01261-01904 Version 3

Safety Recall: Headlight LED Lens Film Delaminates

Supersedes 14-051, dated January 22, 2015, to revise the information highlighted in yellow

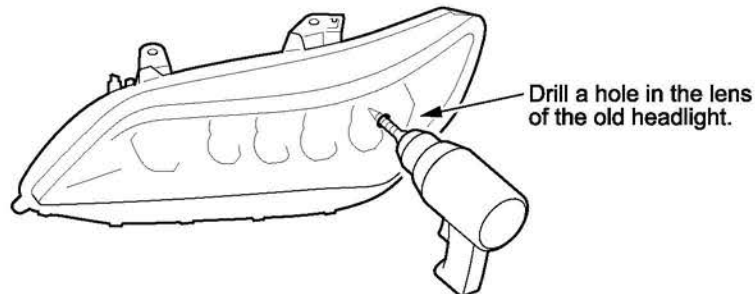
NOTE: To differentiate the original head light assemblies from the improved ones, the improved assemblies have the letter "O" in front of the ID code.
